Proposed Change Order
City of Needles Well No. 11 Treatment Plant Upgrade Project

PCO NO.: 7
SUBJECT: Generator Relocation
FROM: Water Works Engineers
AUTHOR: Joe Riess

Project: 1307 River Road - Well 11 Improvements

Reference: Generator relocation

| | | | | | | | CHECKED J. RIESS | | | | | DRAWING NO. E-101 |

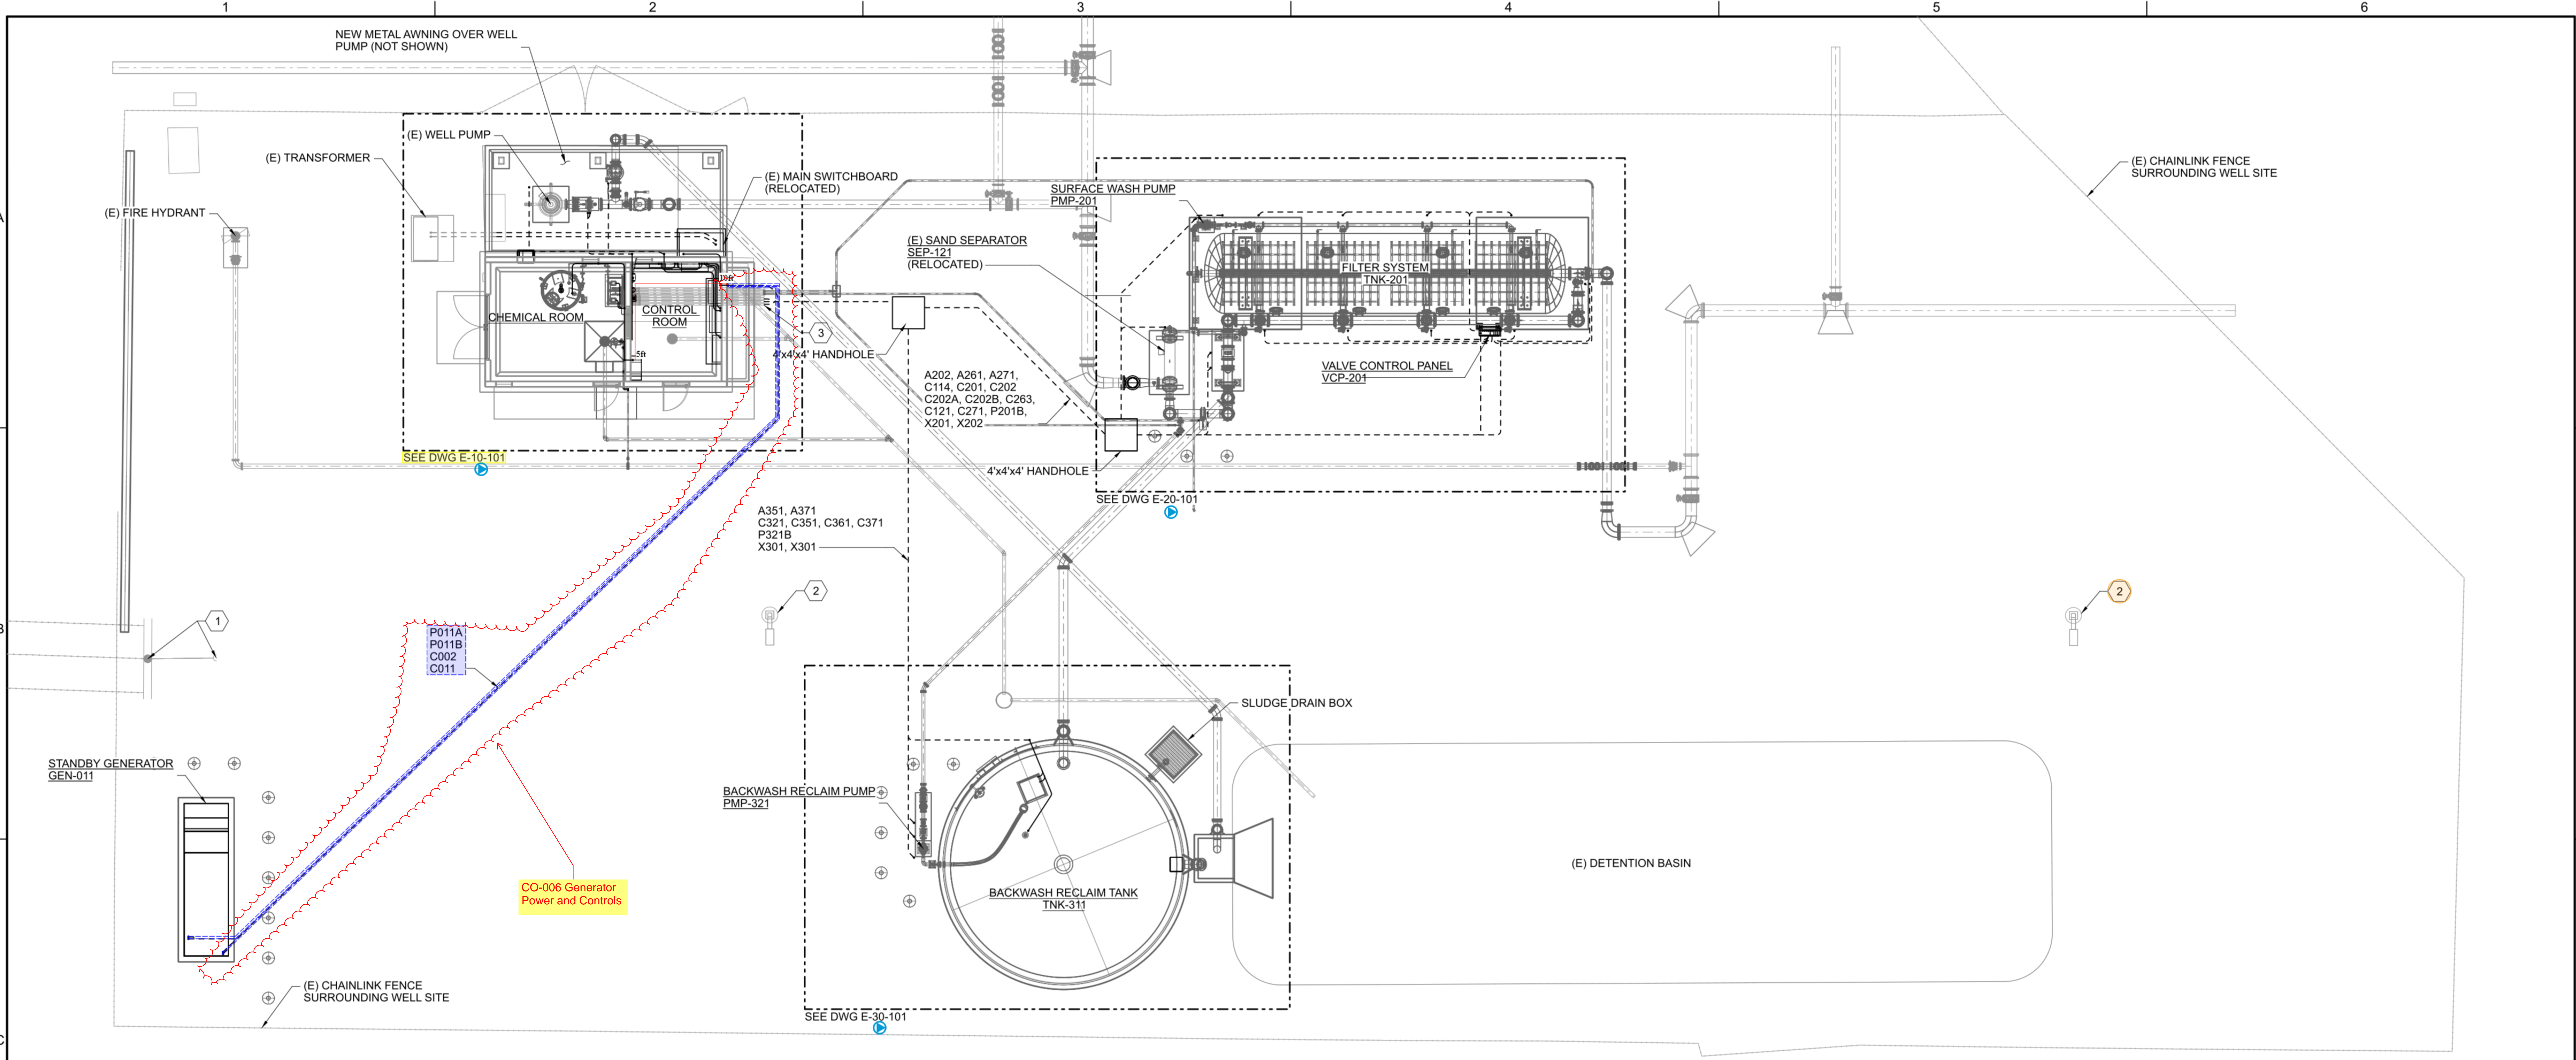
1. Relocate generator to Southwest corner of site as shown on the Drawings. Provide new buried conduit and wire to new generator location.

1. During project scoping, the new generator was located West of the existing building and transformer. After survey of the site was completed, it was discovered that the location of the generator would block entry to site from the existing 30-ft wide gate and be located over existing primary electrical conduit and wires. Relocating the generator to the Southwest corner of the site prevents it from obstructing access through the gate and does not interfere with the existing electrical conduit.

2. Overexcavation 5-ft horizontally and vertically around the generator foundation was recommended in the April 2023 Geotech Report. The original generator location was near the existing fire hydrant and buried power conduit. Relocating the generator to the Southwest corner of the site provides more working room around the generator pad and provides clearance between the overexcavation work area and existing buried utilities.

3. The additional distance from the generator to the automatic transfer switch required larger conductors and conduit.

- F&I conduit and circuiting for the generator at the revised location per the 100% drawings;
- F&I conduit and circuiting for the following conduit tags: P0011A, P011B, C002 and C011 (Approximately 120');)
- Conduit will be installed with the use of PVC underground, GRC & EMT aboveground, Nema-1 indoor, Nema-3R outdoor, as required per code minimum;
- Allowances have NOT been included in this proposal;
- Credit / Deduct:
 - (1) 600amp power circuit (2-2-1/2" PVC, 3-3/0, 1#1) to the new 800kw generator from the ATS (Approximately 82');
 - (1) Conduit and wiring for controls (1-1" PVC, 6#14, 1#14) to the new 800kw generator from the ATS (Approximately 82');
